Beachwood Planning and Zoning Commission Meeting Agenda – Amended
Tuesday, December 3, 2024, 6:30 PM
at Beachwood City Hall, Council Chambers,
25325 Fairmount Boulevard, Beachwood, Ohio 44122

MEMORANDUM
CITY OF BEACHWOOD
PLANNING AND ZONING COMMISSION MEETING

P & Z 2023-17 Applicant has requested preliminary site plan approval for residential development of cluster homes to be located at PPN 741-29-020 North Woodland Road (Fairmount Blvd.)

PROPOSED DEVELOPMENT PLAN

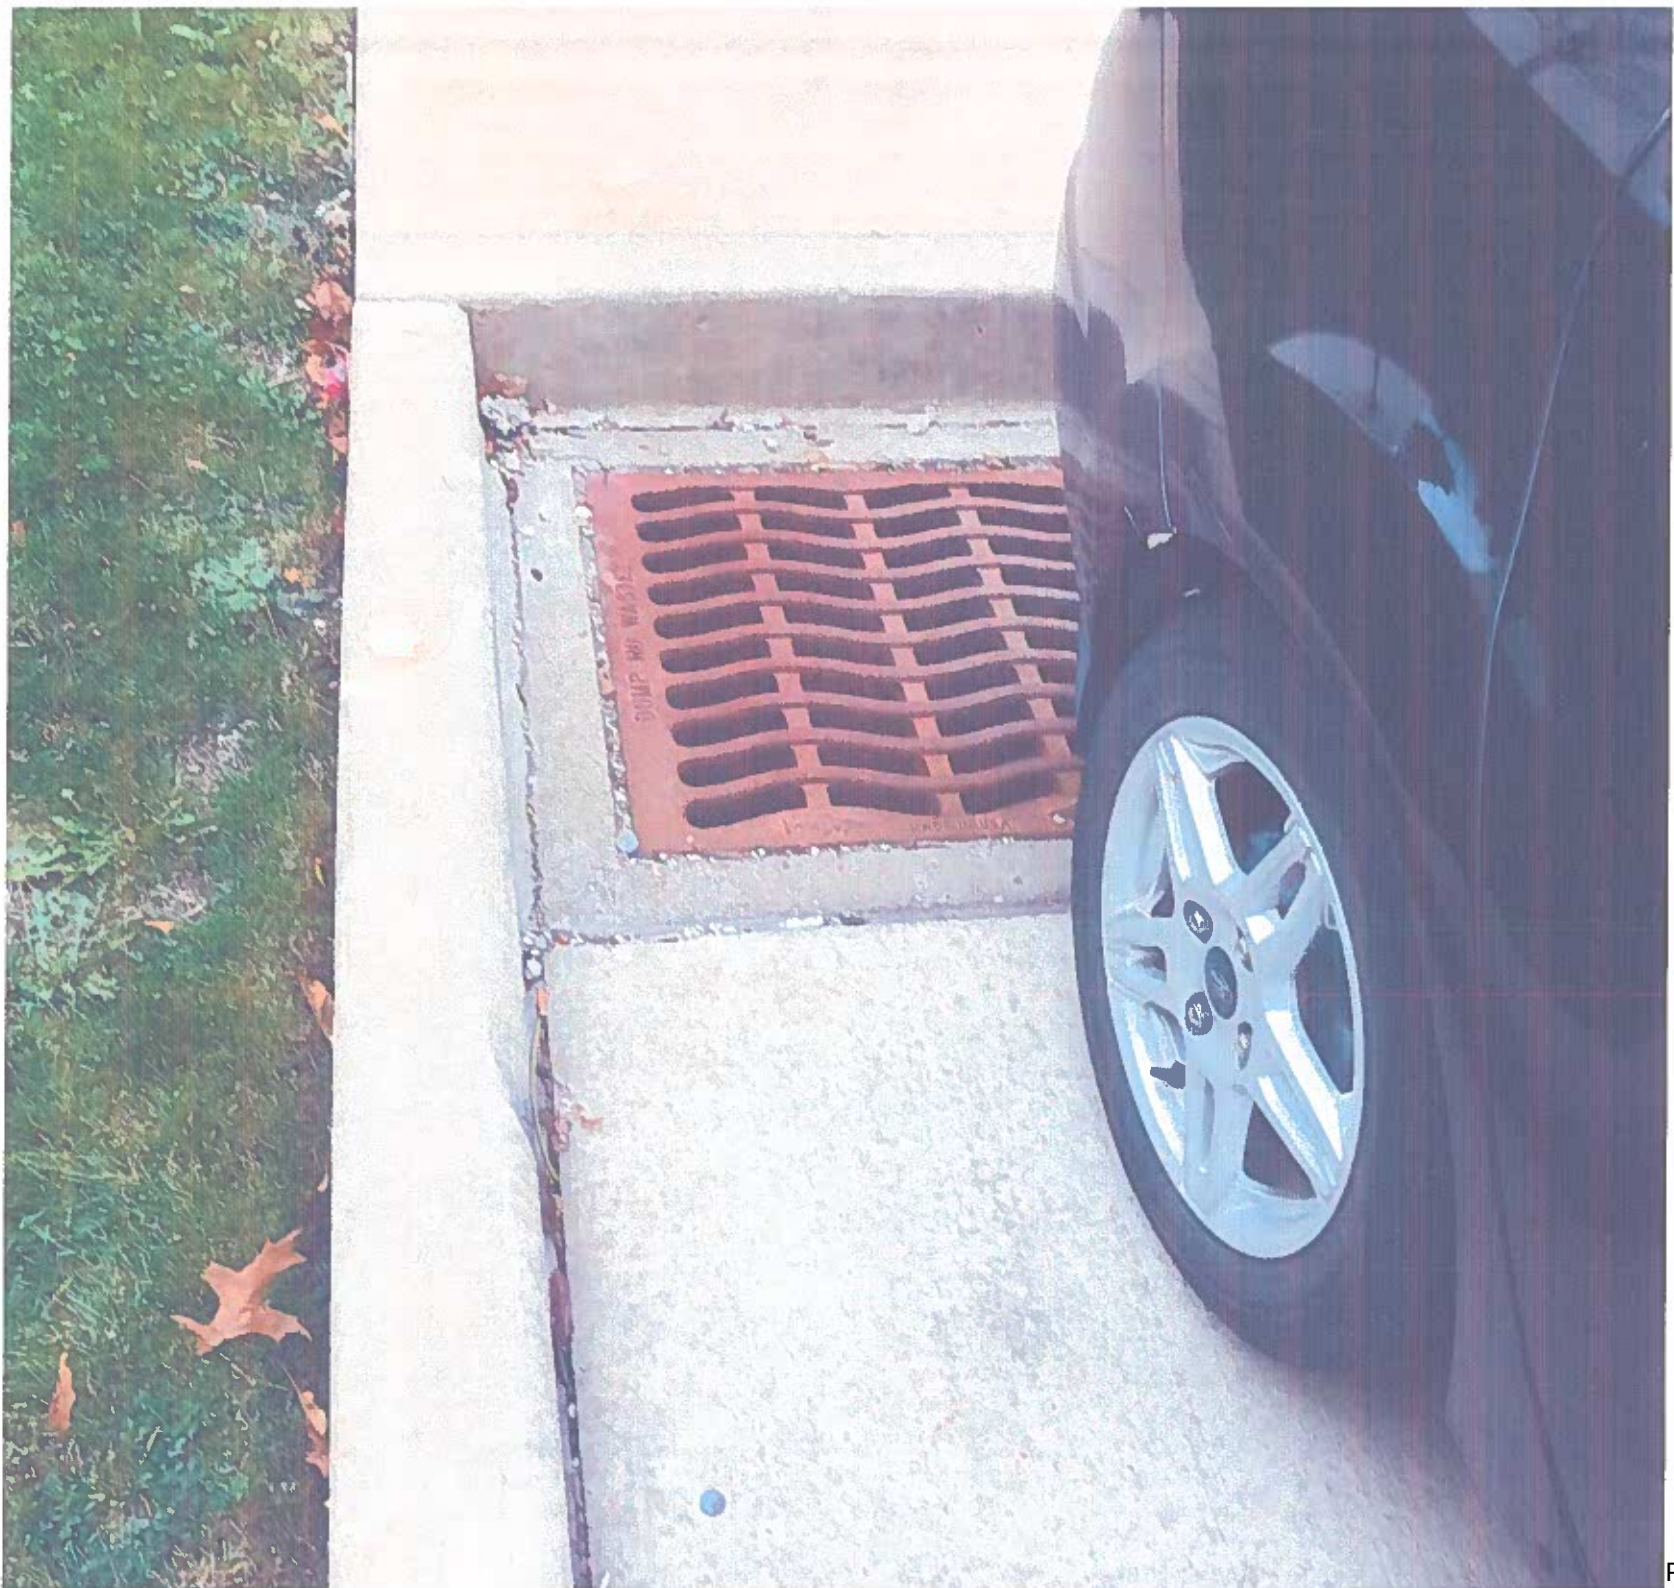
This request is for both preliminary and final site plan approval for a dumpster enclosure. The subject site is in the U-8A Industrial and Office Mixed-Use District. The applicant is proposing to install a black chain link fence enclosure 20 feet by 18 feet for the purpose of screening dumpsters. The fence would have black privacy slats and would include two (2) ten-foot-wide swinging doors for access. The applicant proposes to install the fence on two (2) existing parking spaces in the northwest corner of the small staff parking lot in the delivery area.

It is recommended that the Commission grant both preliminary and final site plan approval subject to any comments of the City Engineer.

Plat of Lot Split
Chagrin Highlands
Lands Known As Being Part Of Original Warrensville Township Lot Number 68, Now In The City Of Beachwood, County Of Cuyahoga In The State Of Ohio.

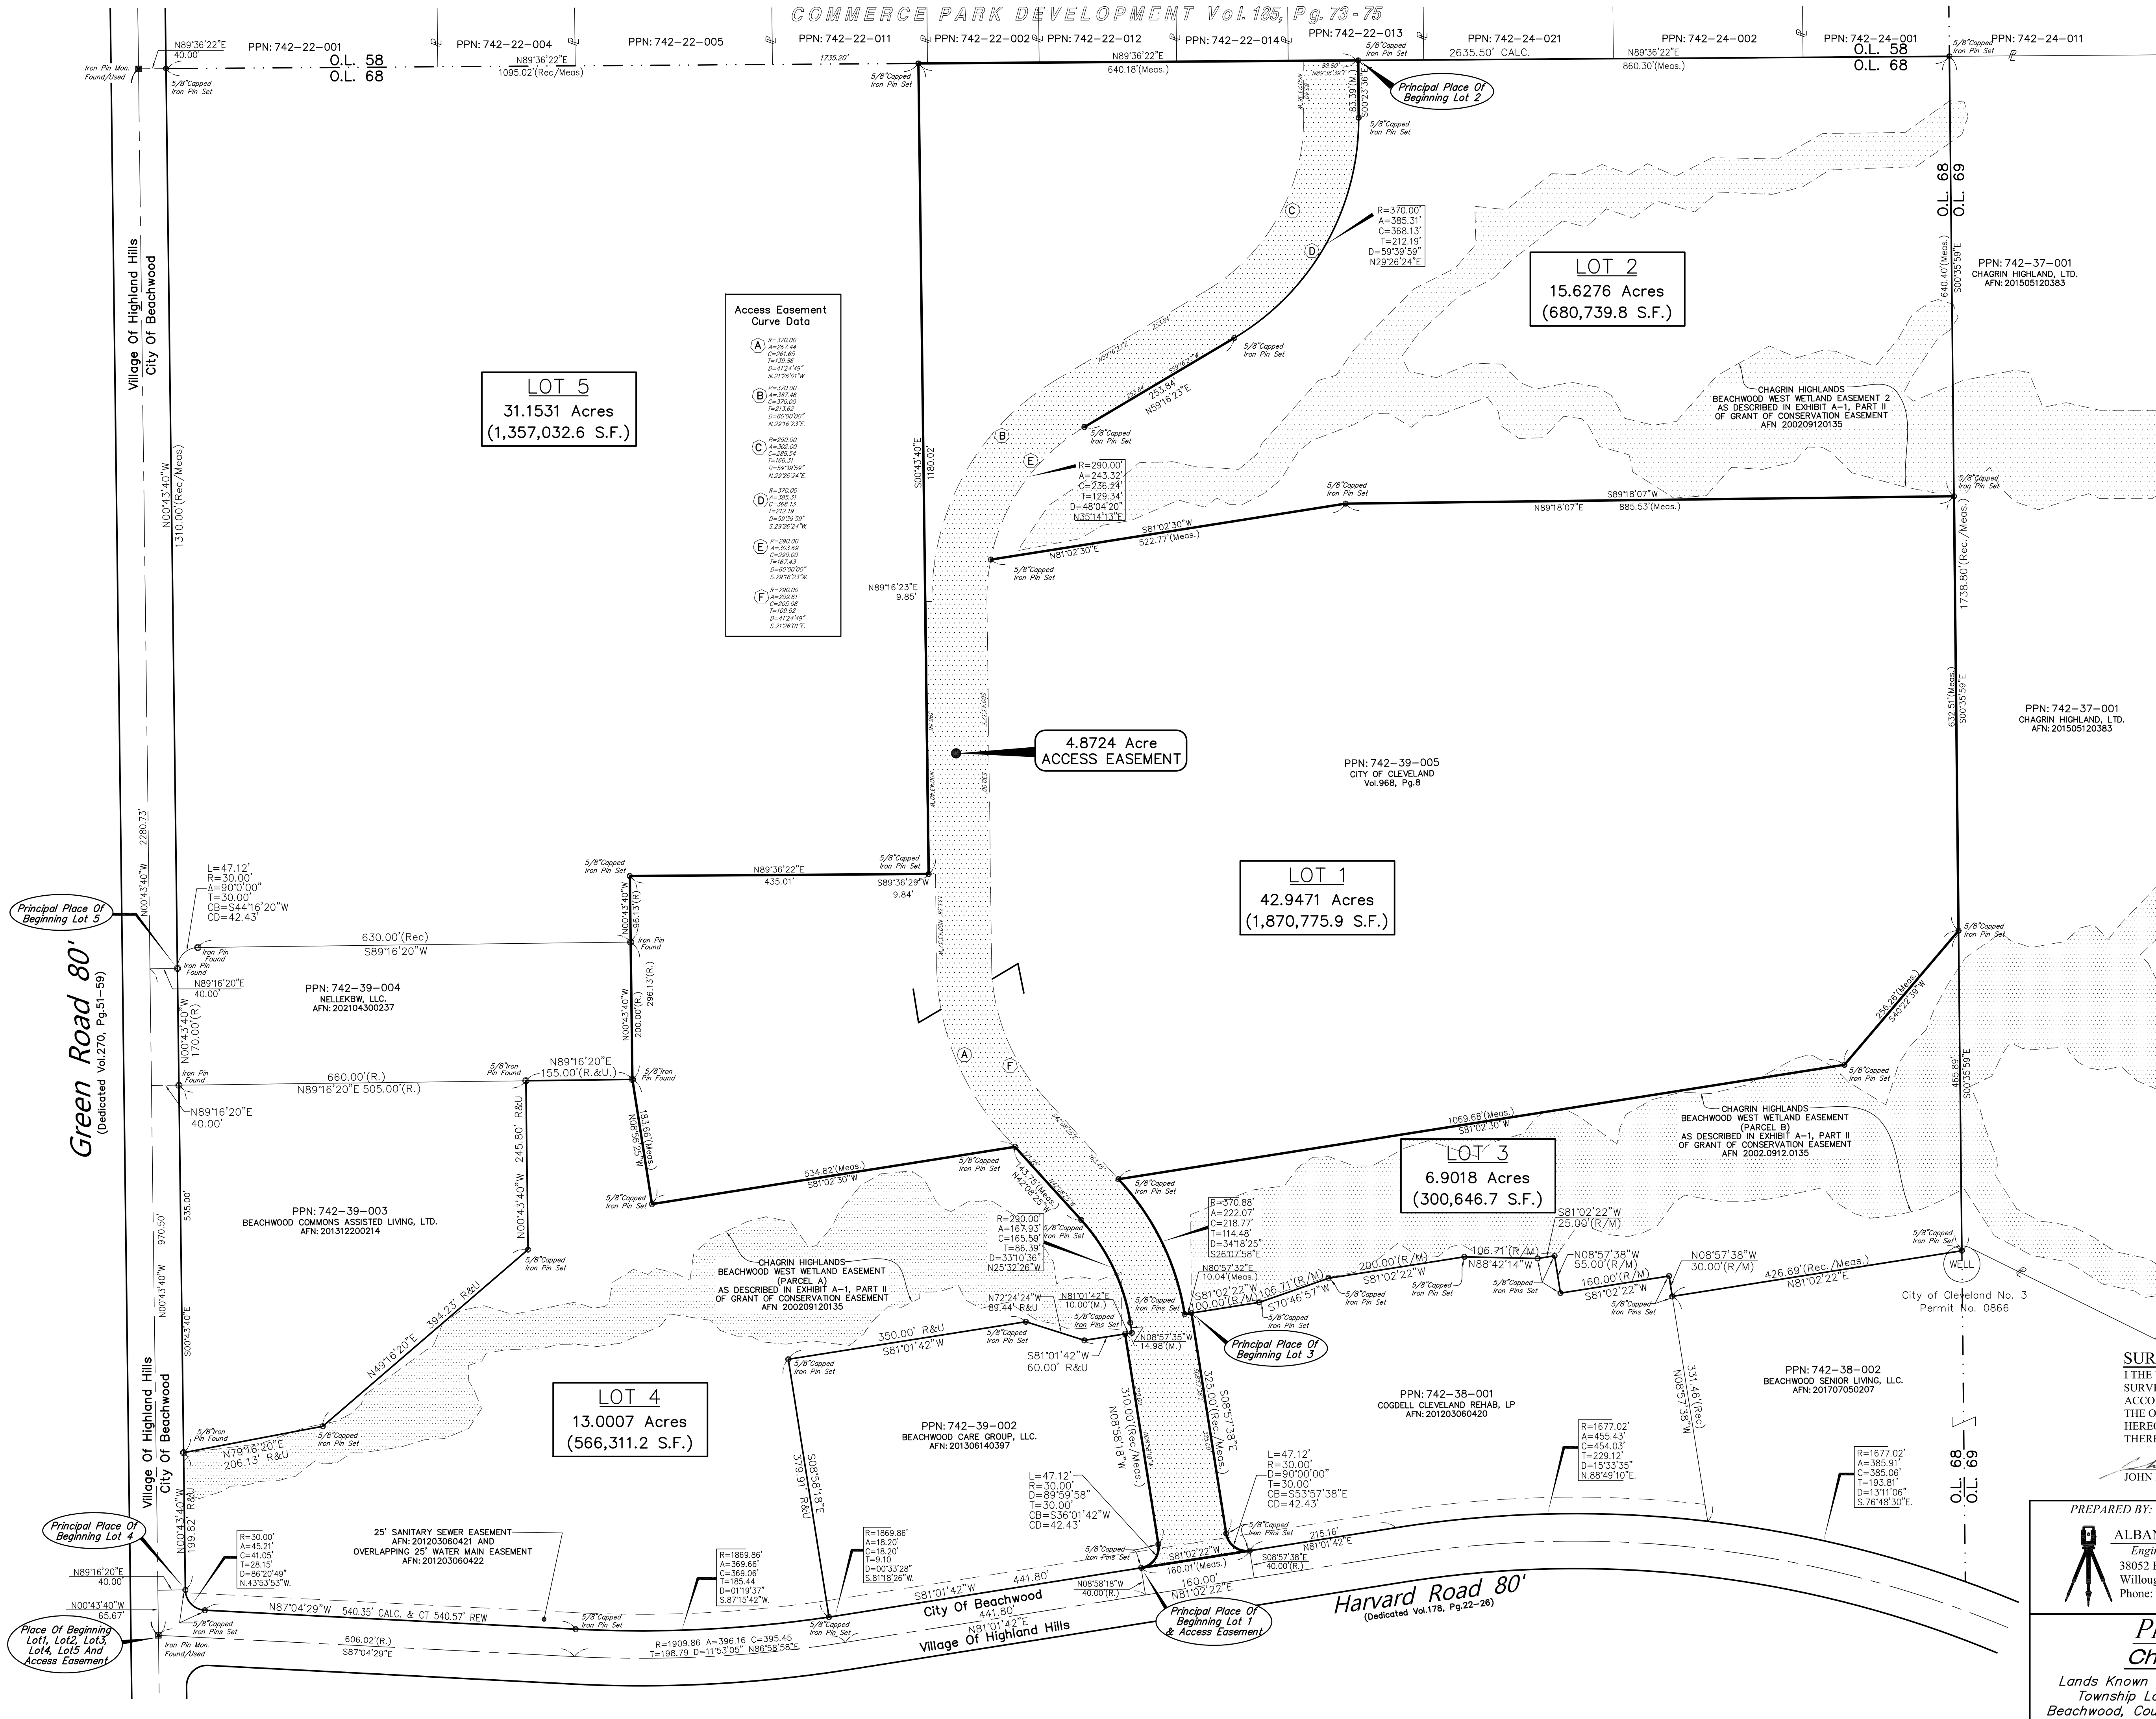
This request is for approval of a lot split plat. The applicant proposes to split existing PP No. 742-39-005 into five (5) parcels. The entire parcel is zoned U-10 Planned Mixed-Use Development District. This lot split plat was approved by the Planning and Zoning Commission in January, but the County requested a revision to the drawing to show the future right-of-way as an access easement so that all of the lots would have frontage until the new street is constructed. Since the City's intent has always been to construct the connector street, the requested change does not impact the intent of the original approval granted by the Commission.

This Plat was previously approved by Planning Commission. The intent of the revised Lot Split is identical to the original Plat. The revision to the Plat was to create an access easement for newly created parcels 1.2 and 3. The easement follows the exact path a future road will be constructed. Without the access easement, new parcels 1,2 and 3 would not have access to a public right-of-way (they would be land locked) and this is not permissible by the County.

It is recommended that the Commission grant approval of the revised lot split plat as submitted.

We hereby recommend approval of the revised Plat.
